# SERVICE BULLETIN

M-1064

## DYNA, SOFTAIL AND XLH SERVICE MANUAL UPDATE

The following errors appear in Chart 1 and Chart 3 of Turn Signal Troubleshooting as printed in some 1997 Service Manuals:

### Chart 1: Turn Signals Will Not Cancel.

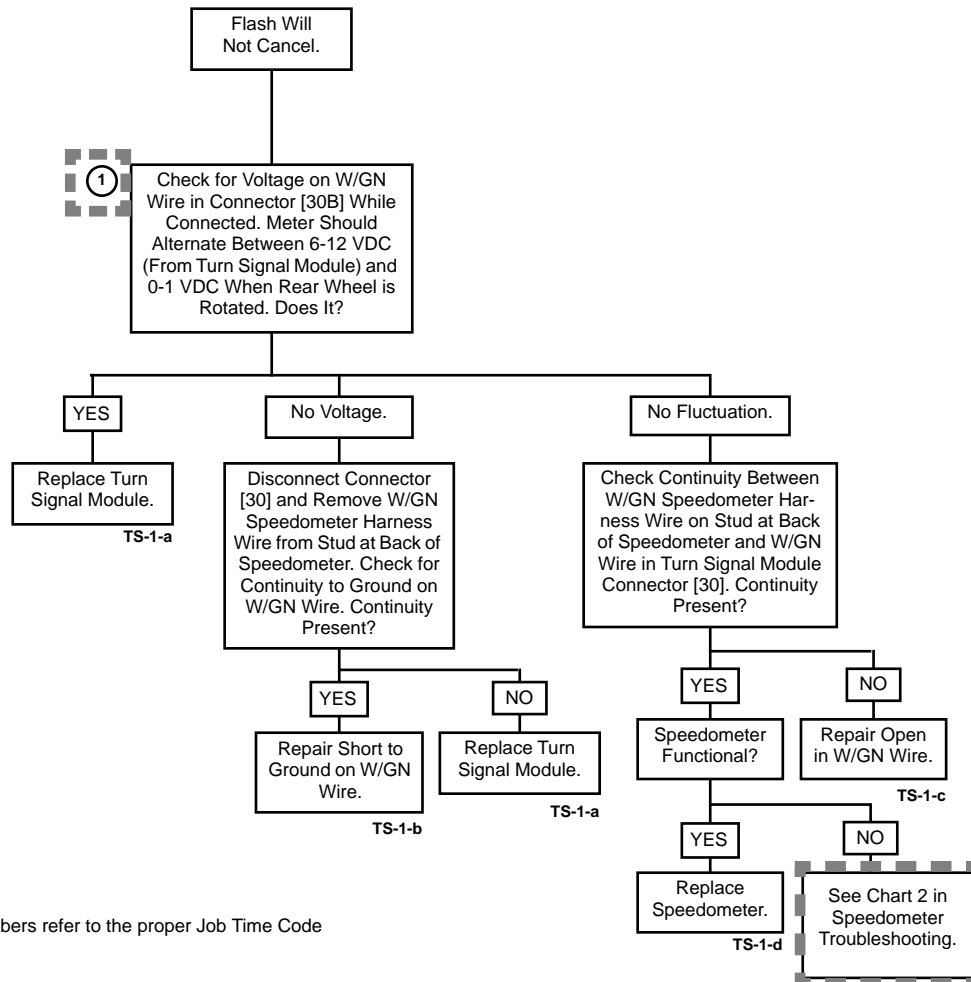
- Chart 1 of Turn Signal Troubleshooting has an incomplete box. The lower right hand box which reads "See Chart 2" should read "See Chart 2 of Speedometer Troubleshooting".
- Diagnostic Note 1 in Chart 1 of Turn Signal Troubleshooting should be deleted from the XL and Dyna Glide manuals (but remain in the Softail).
- On Chart 3 of Turn Signal Troubleshooting three boxes are missing.

The following pages show the correct troubleshooting charts. Changes are shown within the dashed lines. Please note these revisions in your manuals.
